BWROG HUMAN FACTORS ENGINEERING - CONTROL ROOM SURVEY SUPPLEMENT

In response to recently formulated regulatory requirements for design reviews of nuclear power plant control rooms (NUREG-0660, NUREG-0700), Cleveland Electric Illuminating Company has undertaken a preliminary human factors evaluation of the Perry control panels. This one week review was performed by operations and engineering personnel from three utilities, two human factors consultants, and a representative from General Electric Company. General conclusions of the survey team are as follows:

PHOTO #57

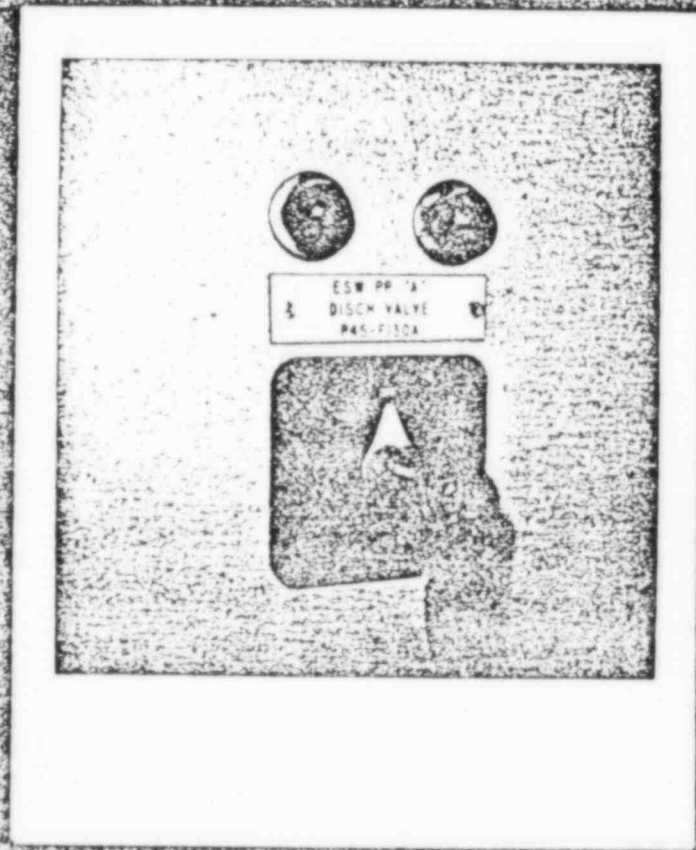
Switch escutcheons on Panel 001 list
incorrect position options.

PHOTO #58

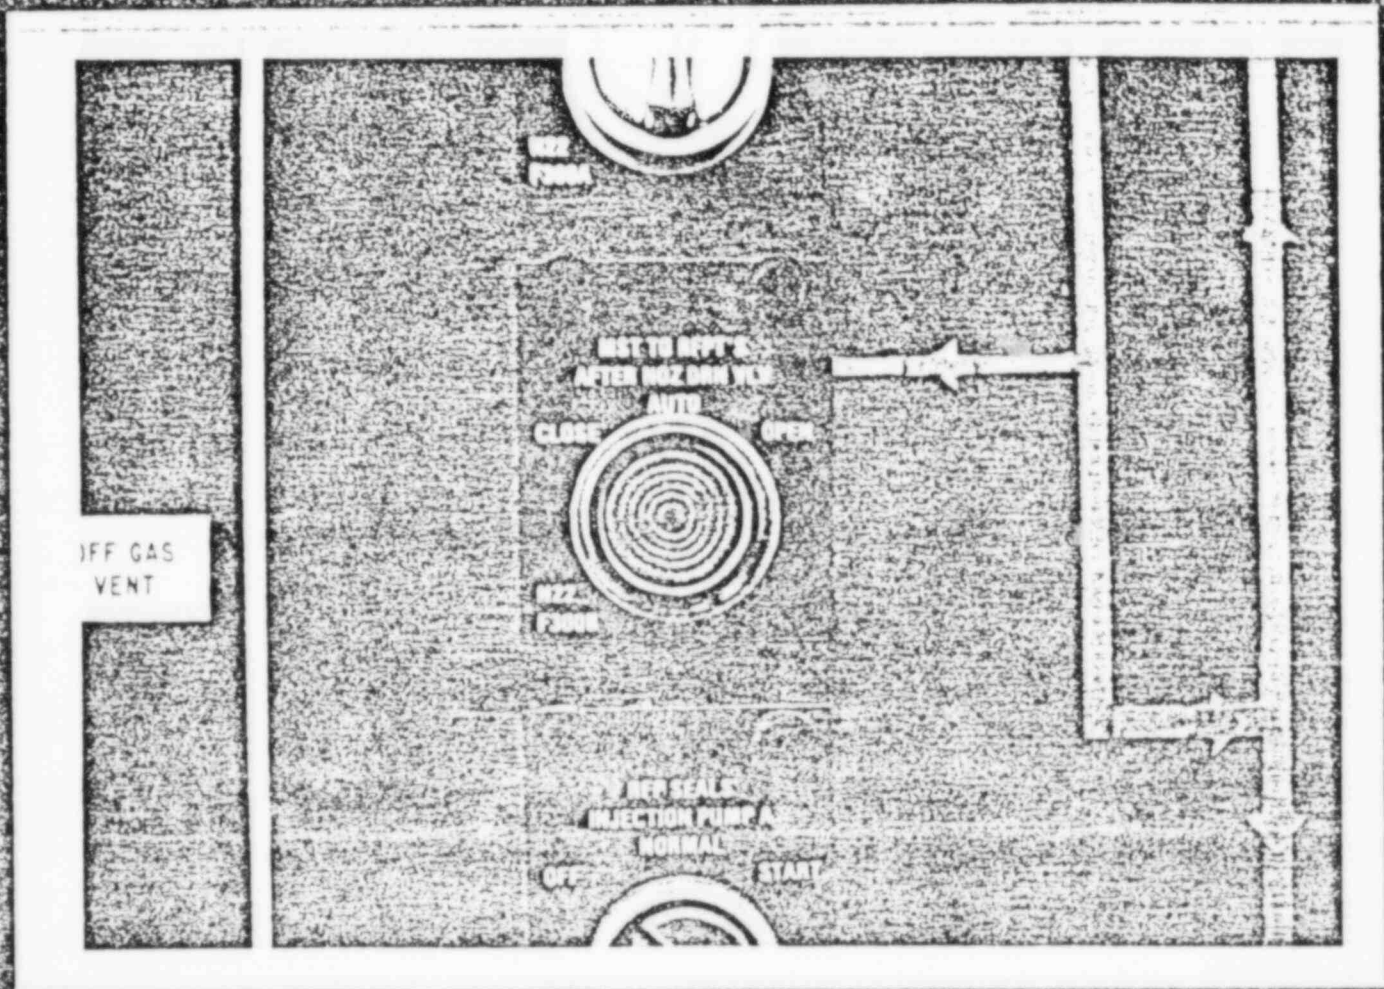
A rotary switch escutcheon is used for this pushbutton switch.

PHOTO #59

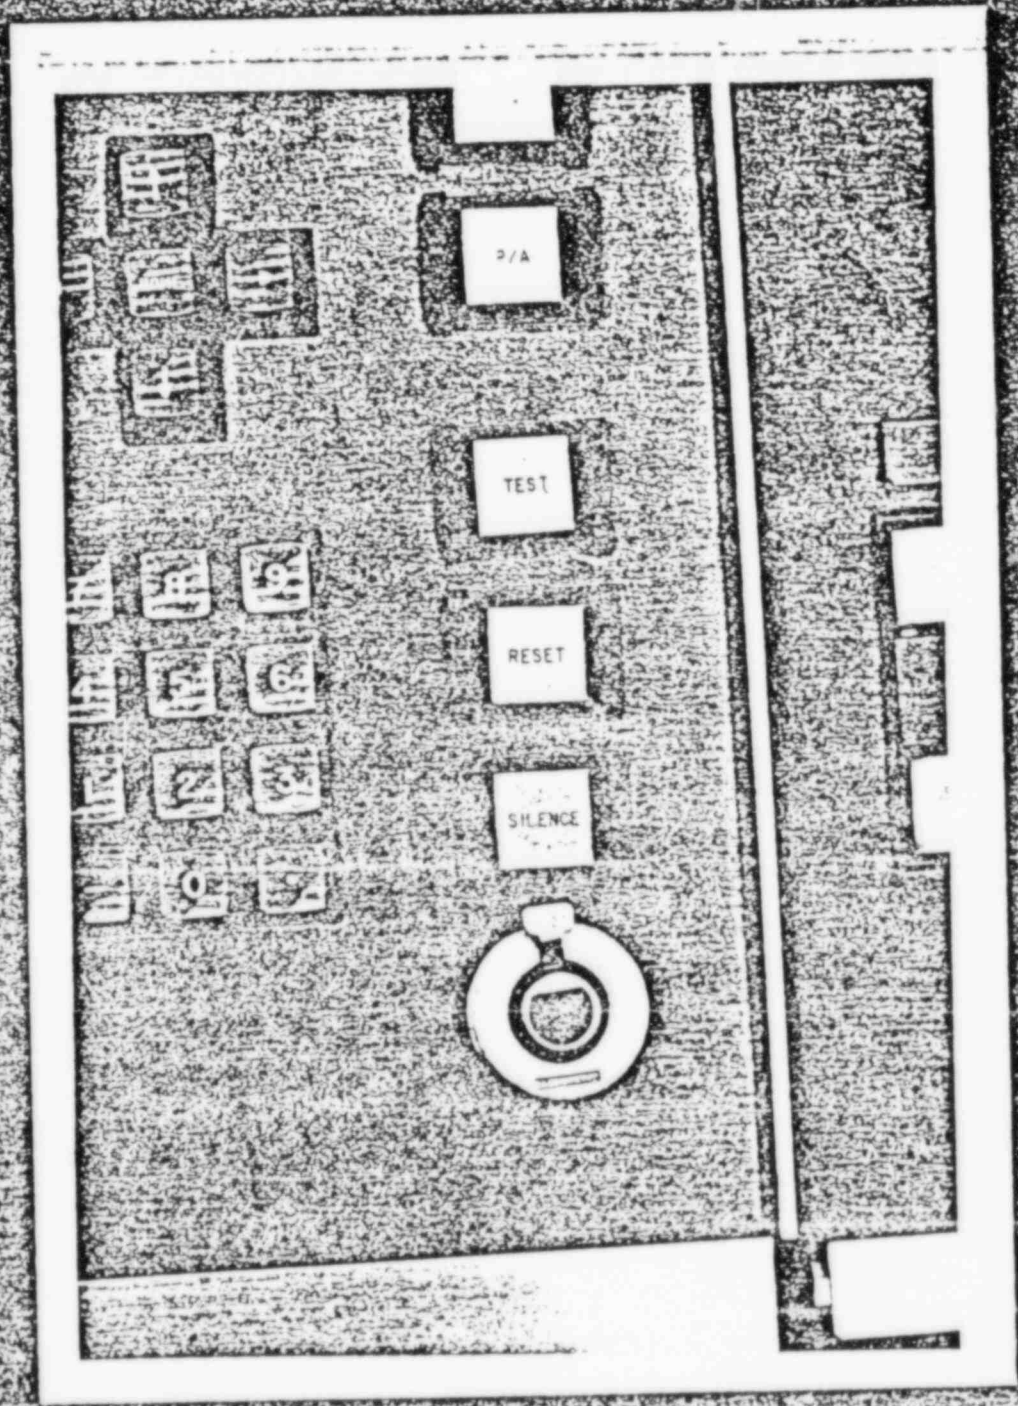
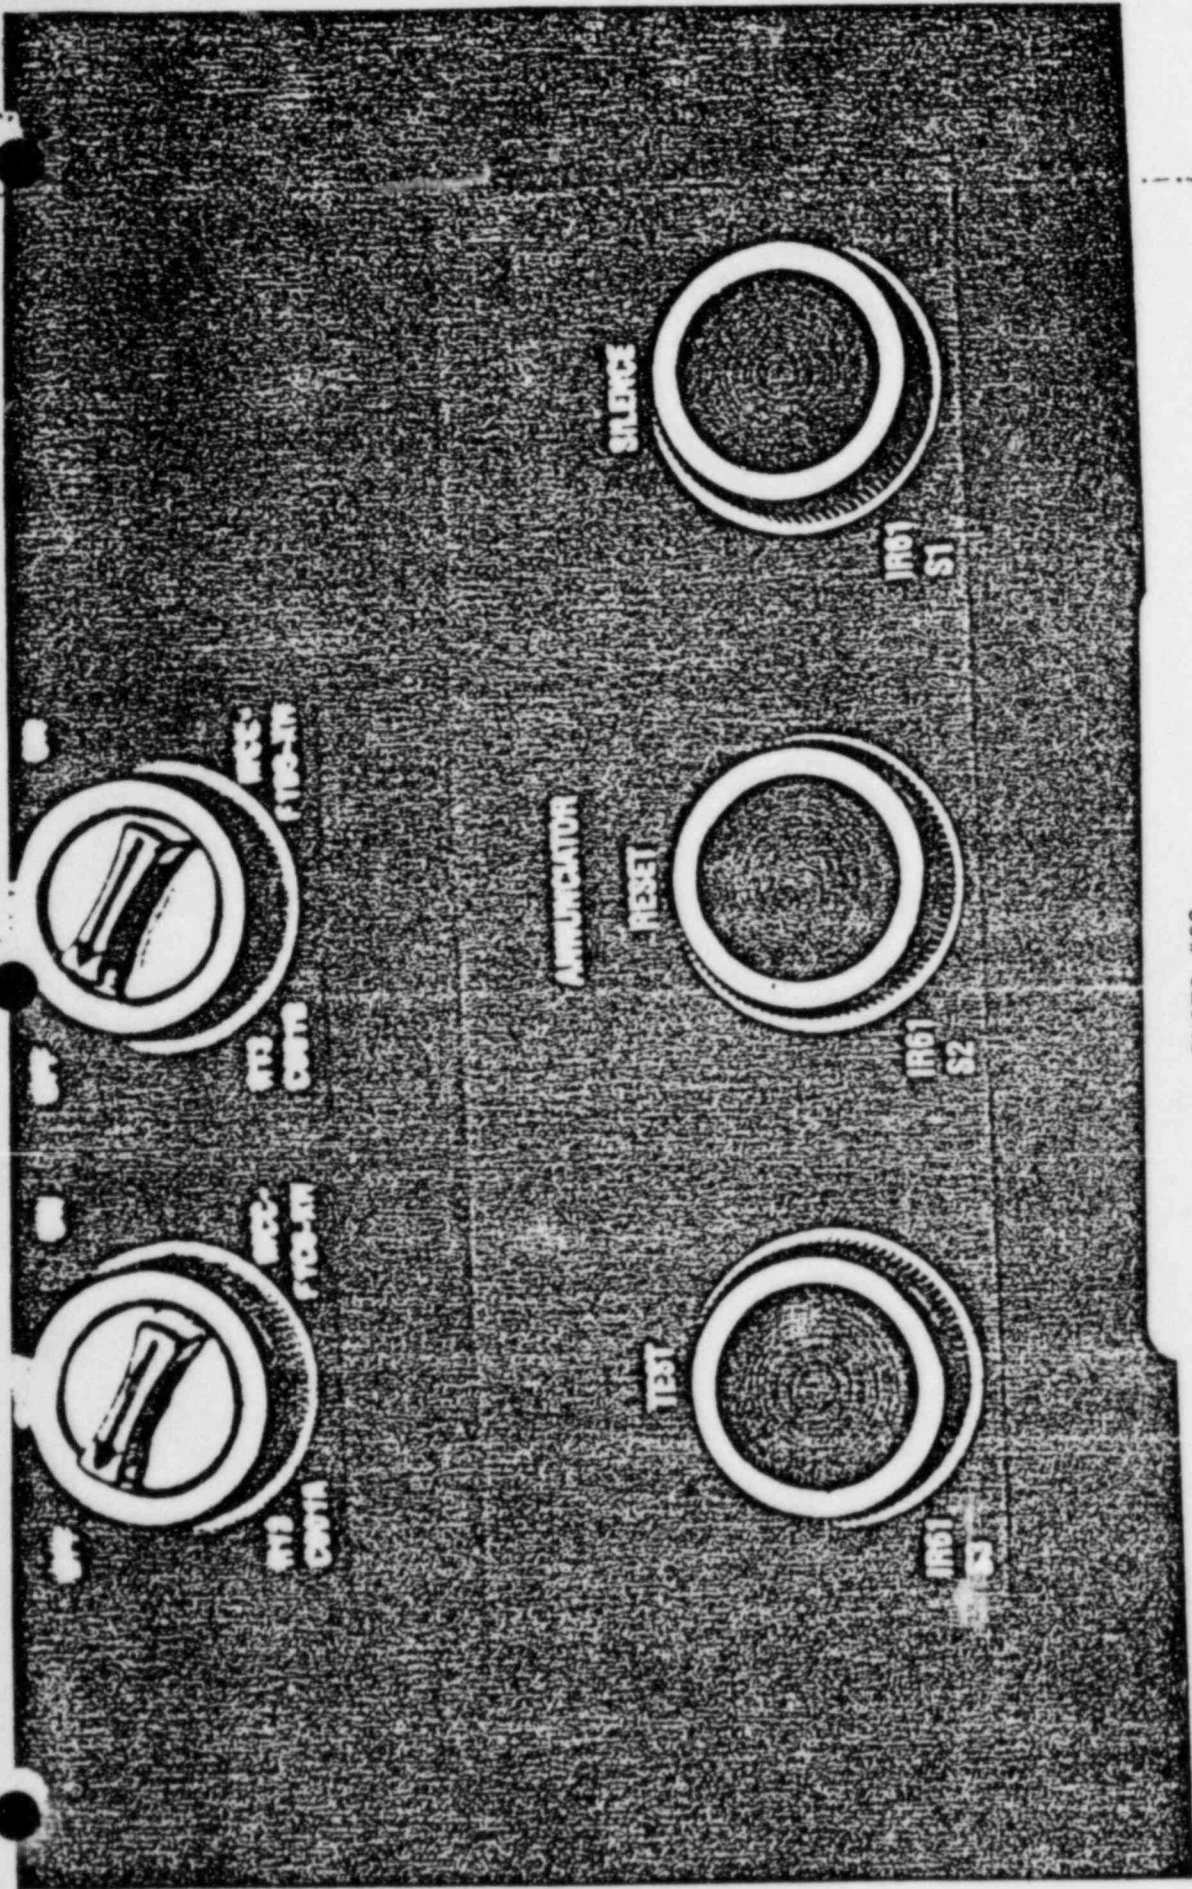
| 16. One set of annunciator response buttons on panel 680 is of a different style and configuration from all others (Photos #59, #60). (C5.5) | 4 |

One set of annunciator response buttons on Panel 680 is configured differently from all others (compare to Photo #60.)
